CAMDEN TOWN HALL
LENDLEASE
PLANNING APPLICATION ADDENDUM
APRIL 2020
DESIGN & ACCESS STATEMENT
HERITAGE IMPACT ASSESSMENT

CAMDEN TOWN HALL - PLANNING APPLICATION ADDENDUM

This Design and Access Statement (DAS) and Heritage Impact Assessment (HIA) has been prepared by Purcell at the request of Lendlease on behalf of London Borough of Camden (W), the Client, as an addendum to the approved Planning Application 2019/2238/P and approved Listed Building Consent Application 2019/2257/L. The Statement describes the proposed amendments to the approved scheme that have arisen as a result of investigative survey information and client requests during RIBA Stage 4.

Rooftop plant - Proposed scheme

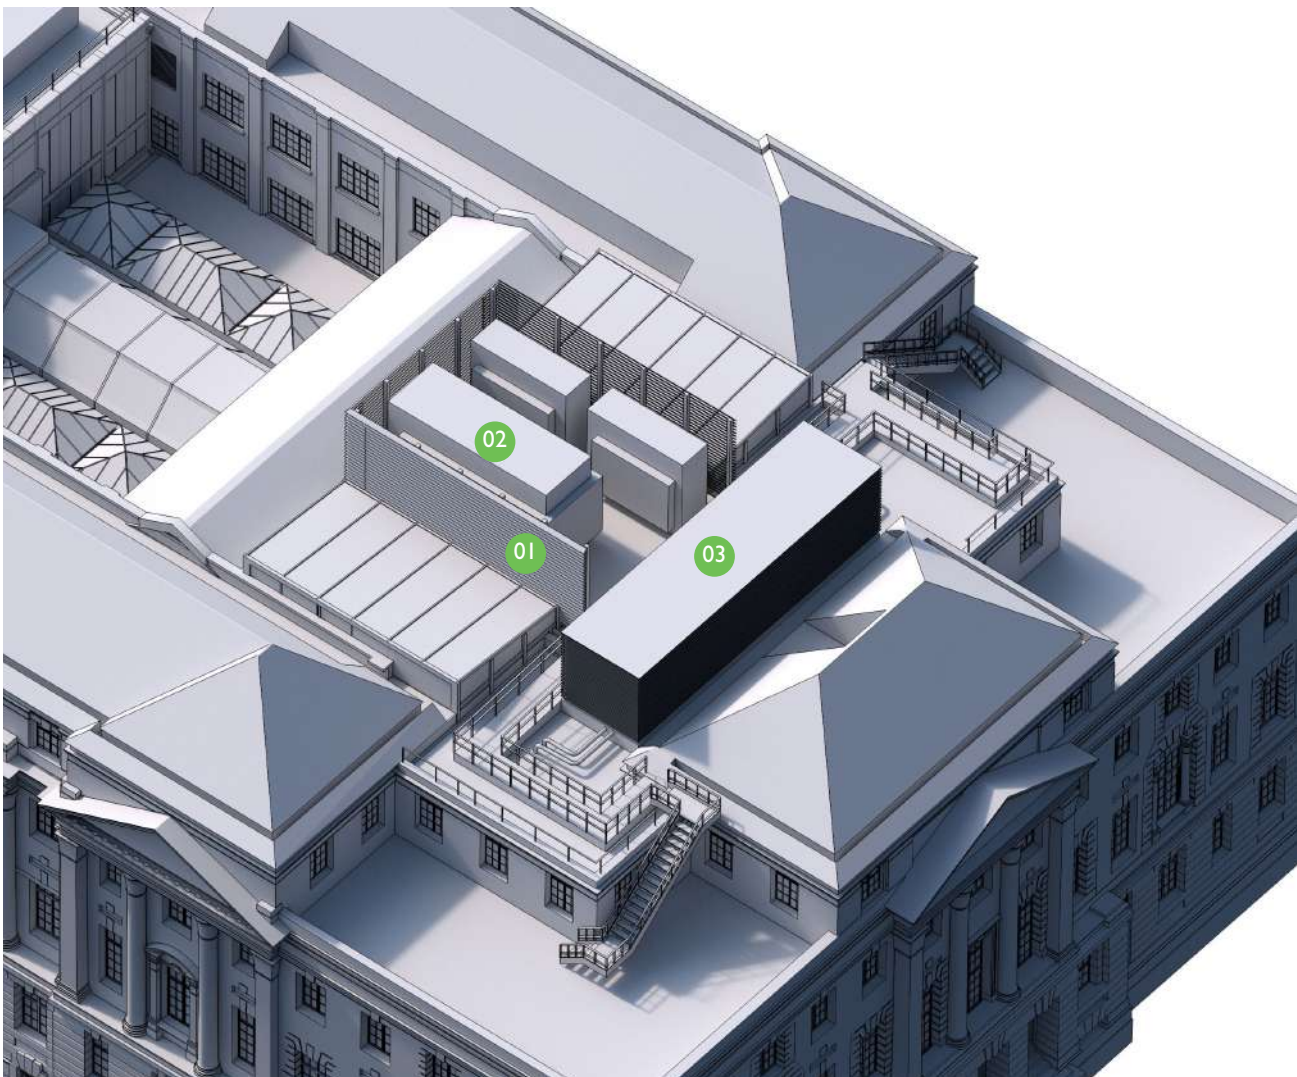
In the original application the existing lift motor room structure was proposed to be removed and replaced with a smaller pump room enclosure. Due to the increased mechanical requirements,

the amended scheme looks to utilise the existing lift motor room structure and re-clad with architectural louvres to reduce its visual impact from street level.

A further change has been made to the roof access strategy with a new compliant metal access stair proposed to replace the existing timber ladder-type stair to the North-West terrace.

- 01 New ASHP arrangement with 1no. large unit and 2no. medium sized units. Attenuation to sides and top of each unit
- 02 Acoustic louvered screening proposed to three sides to avoid noise bleed to Bidborough Street neighbours
- 03 Pump Room formed with existing Lift Motor Room steel structure and clad in new metal louvered panels
